# GENWAL MINE

CHANGE TO THE DRAINAGE CONTROL PLAN  
FOR THE

MINE DISCHARGE WATER  
AERATION TREATMENT FACILITY

Re: Crandall Canyon Mines, C/015/032  
Change to Drainage Control Plan, Water Aeration Treatment Area

DRAWN BY	PJ	SCALE	1" = 50'
APPROVED BY	DS	DATE	2 APRIL 2009
FIGURE	FIGURE 7-13a

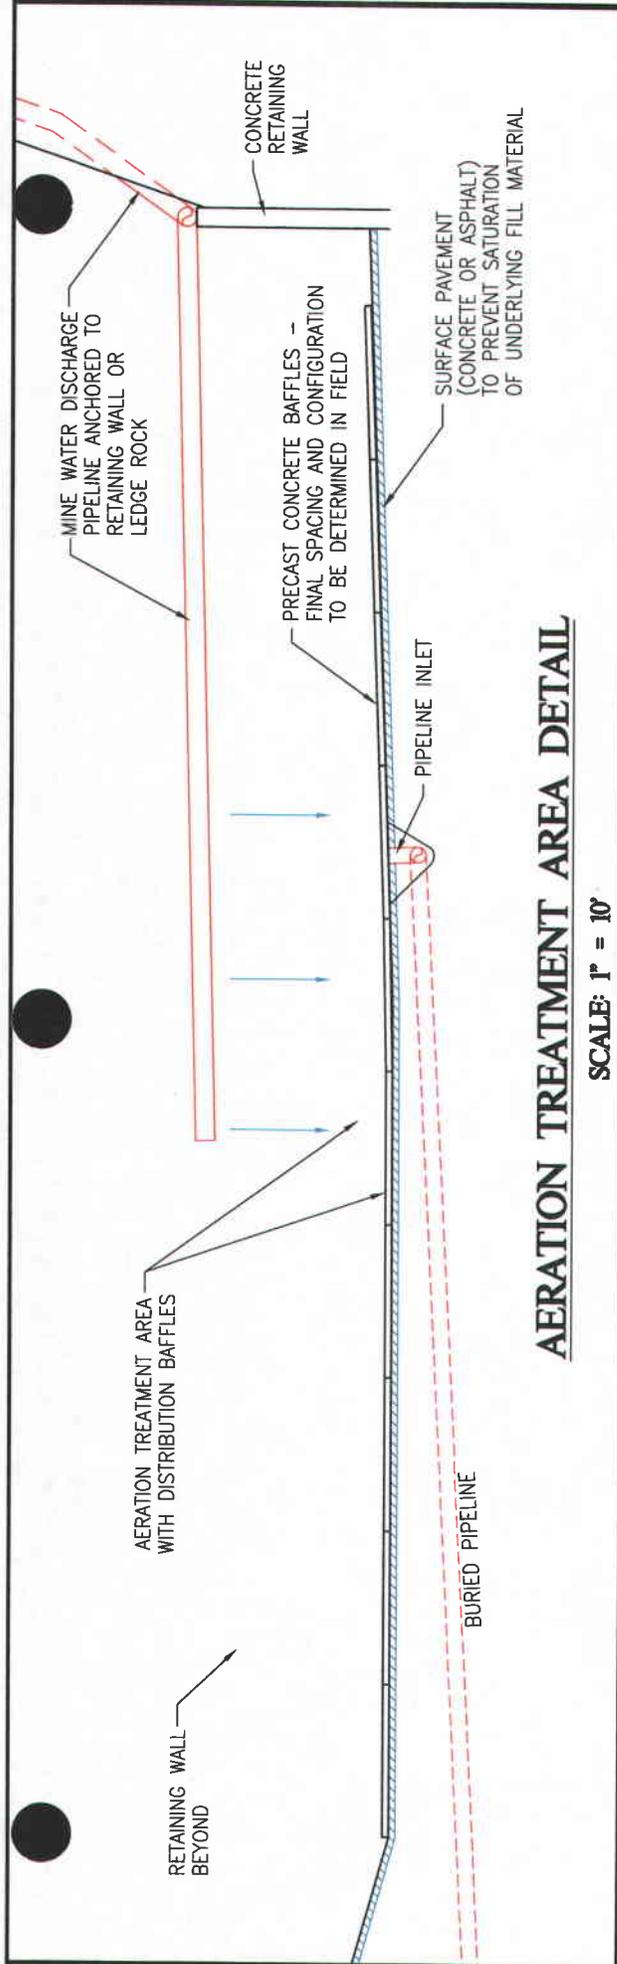
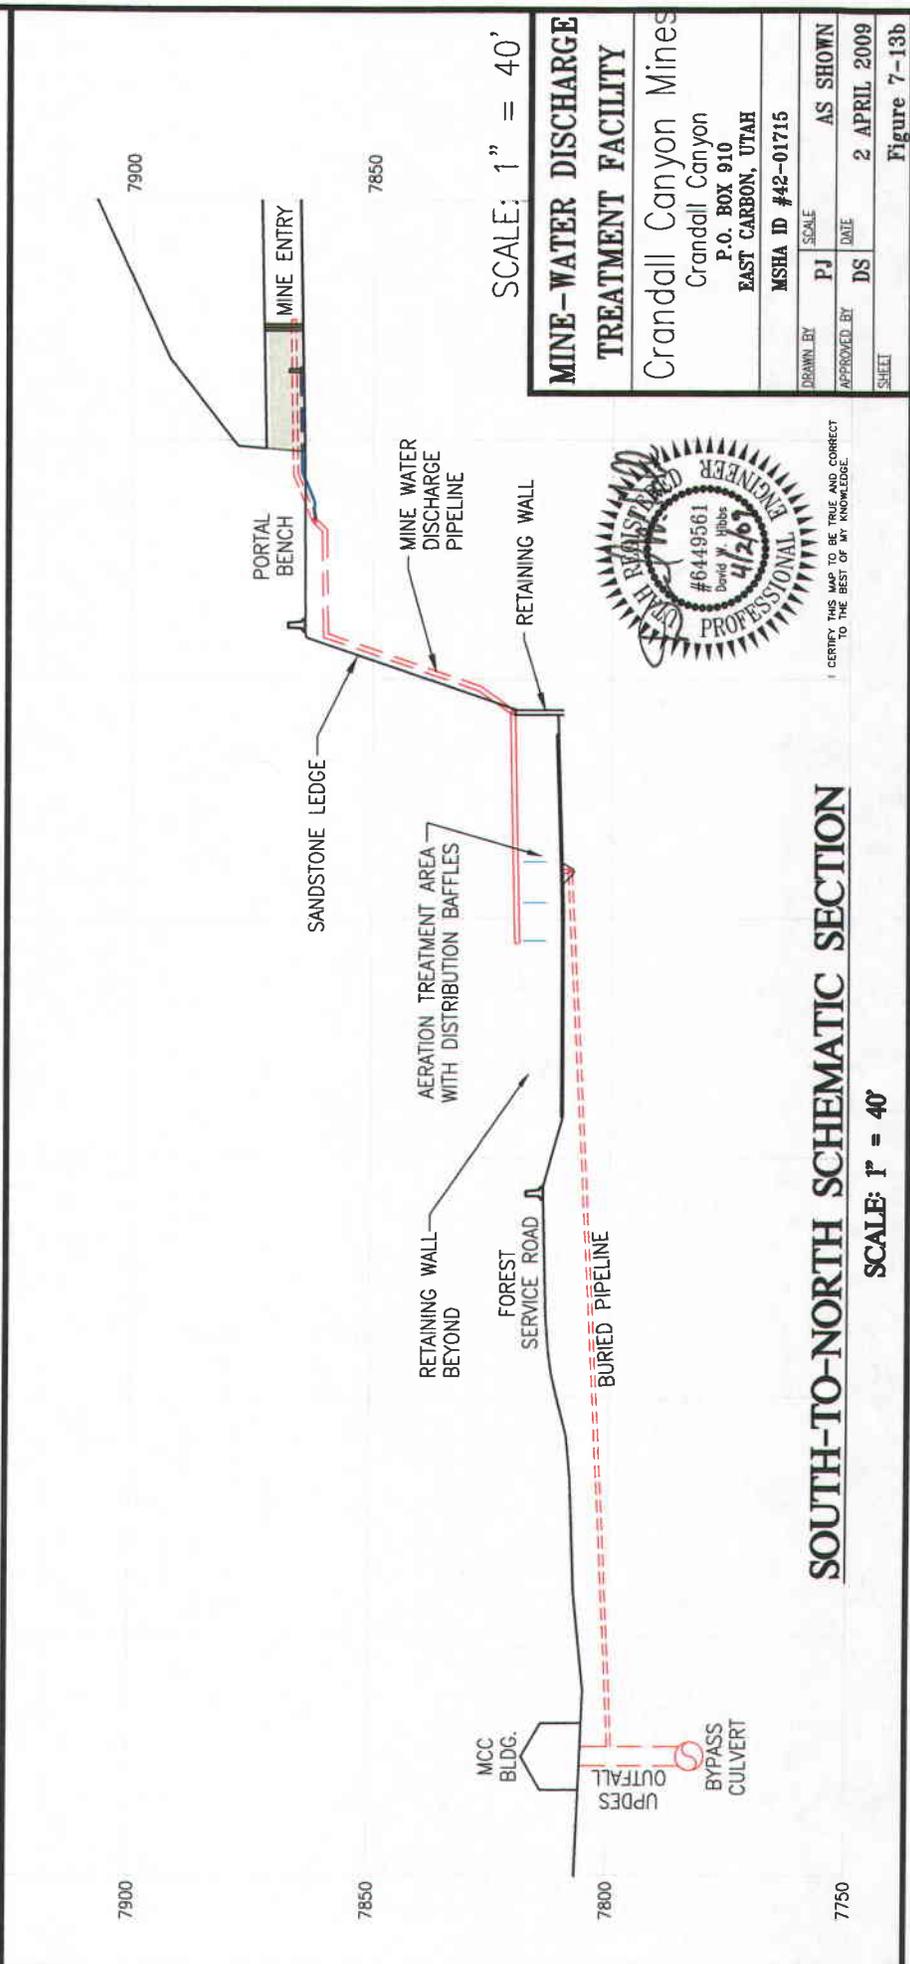
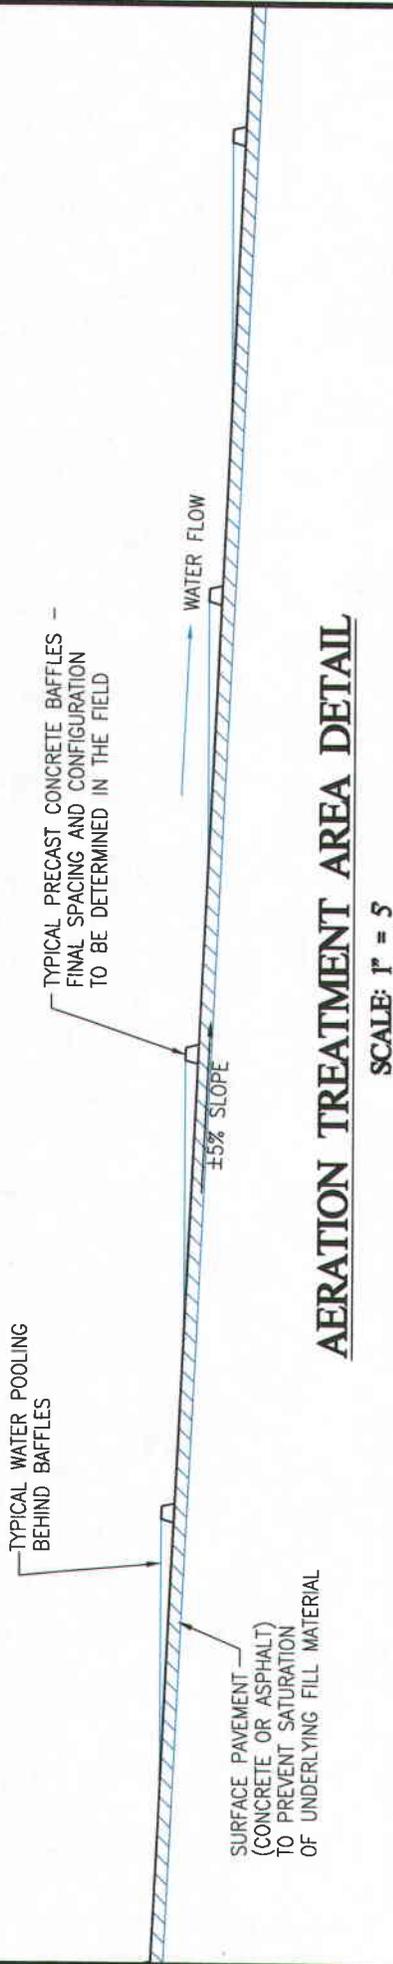
As a result of the Crandall Canyon Mine disaster of August 6, 2007, the mine has been de-activated and the portals have been sealed. Mine water inflow has built up to the extent that water is now discharging from the portals and is discharged through a 12" pipe into Crandall Creek under UPDES permit UT0024368. The mine is presently discharging approximately 400-500 gallons per minute, with the flow fluctuating with barometric pressure and seasons. In early 2009 the iron concentrations in the water began to exceed UPDES limits. Because there is no way to treat the water underground the company is proposing to treat the water with an aeration system located on the surface in the "old loadout" area, immediately below the portal bench. The existing water discharge pipeline would be re-routed so that the mine water would discharge at the upper end of the area. The water would then run across a series of low riffles to spread the flow out over as much area as possible and provide maximum contact with oxygen in the air. The treated water would then be collected at the lower end of the area, routed through a culvert under the road, and would then be discharged into Crandall Creek at the currently approved UPDES outfall monitoring point.

A suitably constructed barricade would be constructed around the treatment facility along the outer edge of the treatment basin (between the treatment basin and the road) which will prevent any disturbed area drainage from entering the treatment facility area, and similarly will prevent any of the mine discharge water from spreading over the adjacent disturbed area and reporting to the sediment pond. See Plate 5-3 for the location of the facility. This treatment area is also designated as ASCA 12 in the Sedimentation and Drainage Control Plan found in Appendix 7-4 and Plate 7-5. See Figure 7-14 for a schematic representation of the aeration facility, as well and the mine-water discharge piping and French drain collection system at the portals.

Between the curbs will be a 2"-3" layer of sorted gravel which will help trap the iron precipitate particles to prevent them from continuing on downstream to the UPDES outfall. The gravel material will also provide a better surface area for the iron sulfides to adhere. This gravel may consist of a crushed limestone to help chemically in the iron removal process. It will also be possible to add a chemical flocculant and/or coagulant to the water at the upstream end to aid in the iron removal process. This gravel/crushed rock layer will be removed and replaced as necessary as it becomes overloaded with iron precipitates.

**AERATION TREATMENT AREA DRAIN PIPELINE LOCATION PLAN**

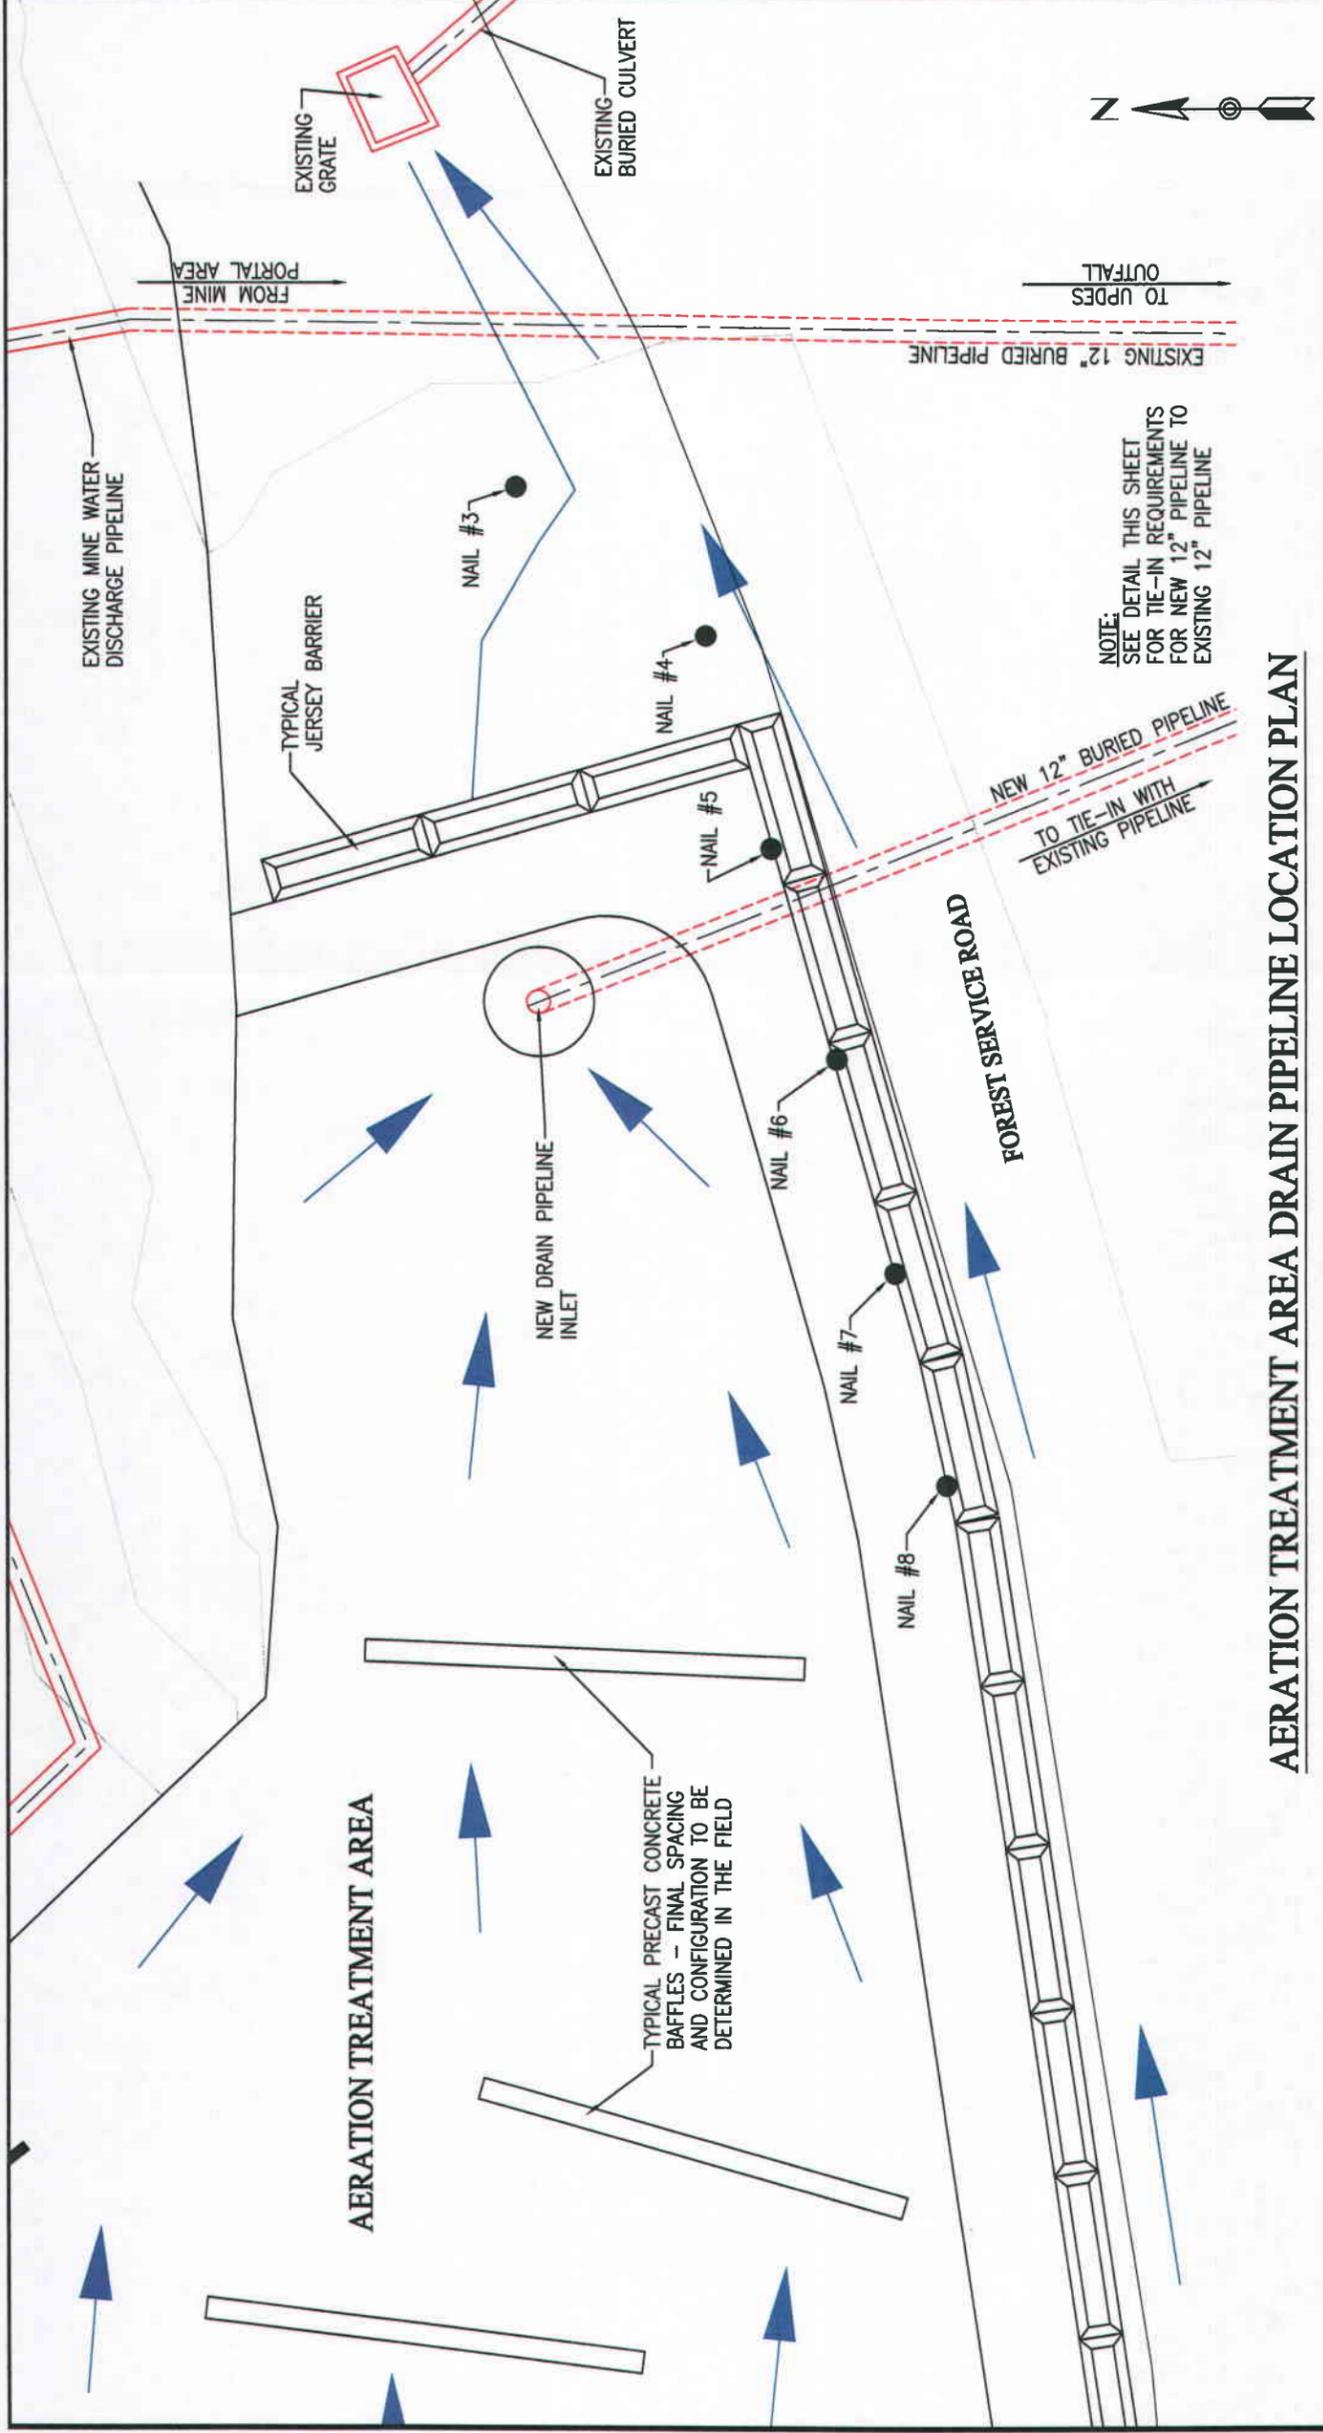
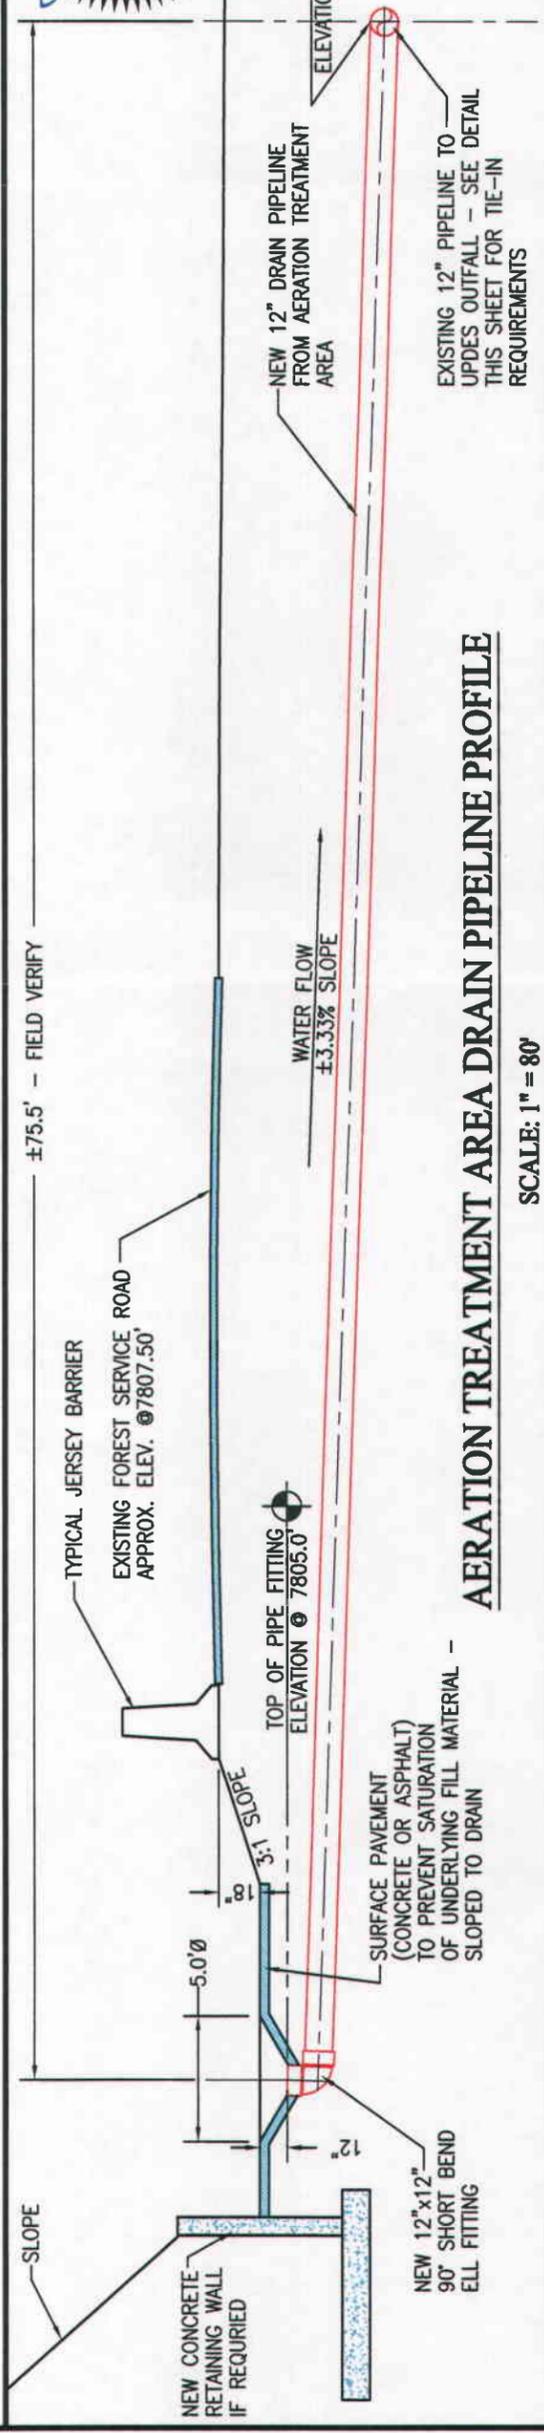
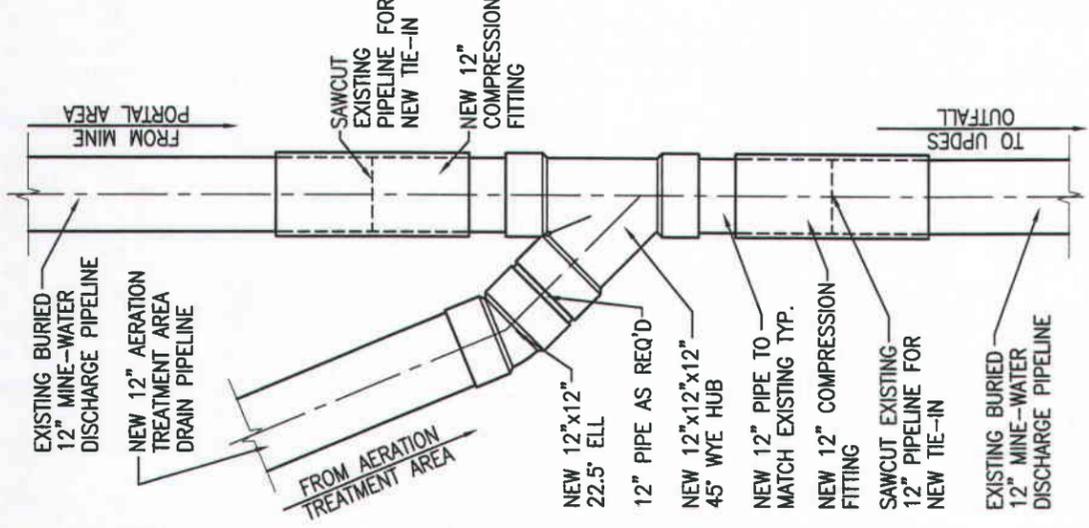
NOTE:  
SEE DETAIL THIS SHEET  
FOR TIE-IN REQUIREMENTS  
FOR NEW 12" PIPELINE TO  
EXISTING 12" PIPELINE
